Executive Order G-70-48-A

Relating to the Modification of the
Certification of the Mobil Oil Balance
Phase II Vapor Recovery System

MOBIL OIL CORP - BALANCE PHASE II

EXHIBIT - 1

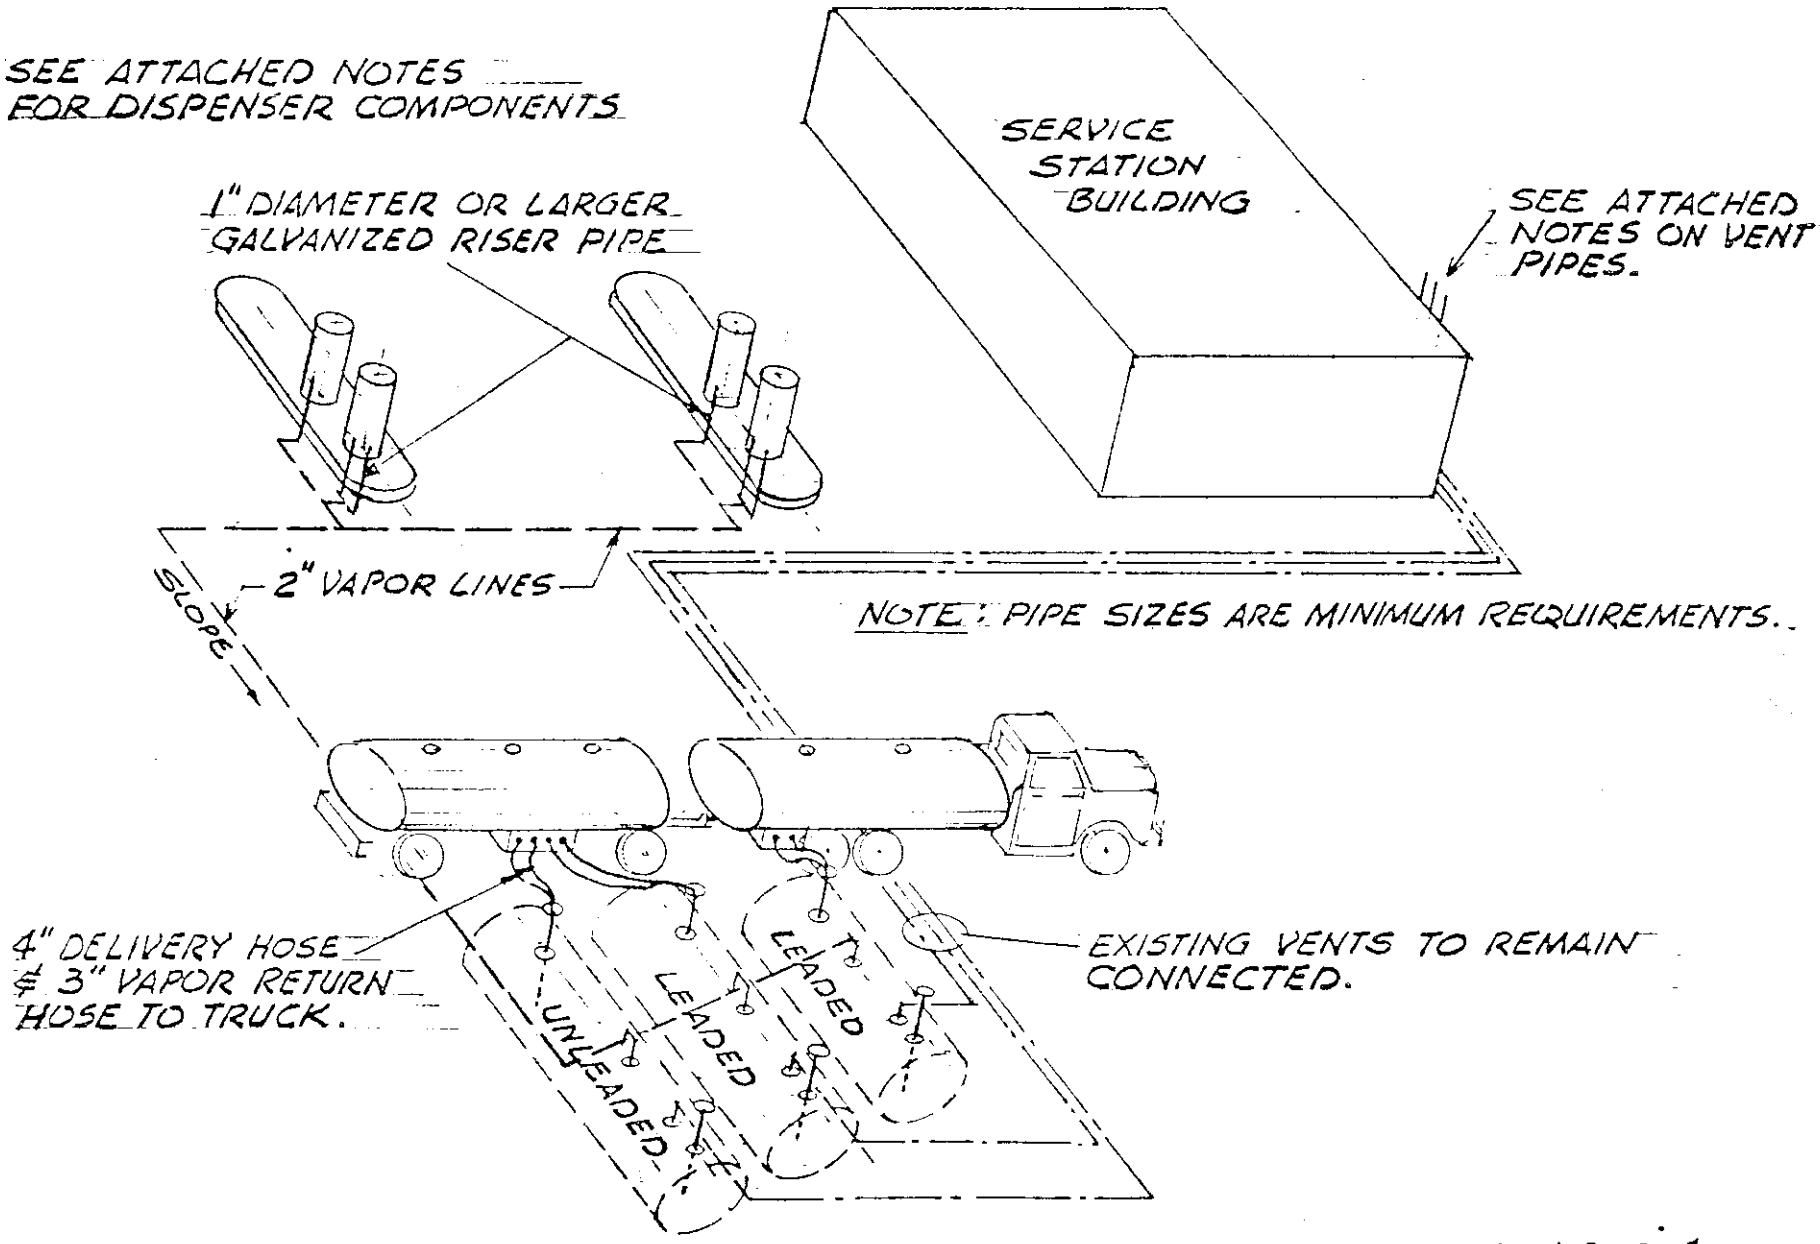
IT IS ORDERED AND RESOLVED: That the Mobil Oil balance Phase II vapor collection and disposal system is hereby modified to include the OPW-7VC nozzle as an alternate nozzle. The system is certified to be at least 95% effective in the self-serve and/or attendant use at gasoline service stations in conjunction with Phase I vapor recovery systems which have been certified by the Air Resources Board. The system is described in Exhibits 1 and 2, attached hereto.
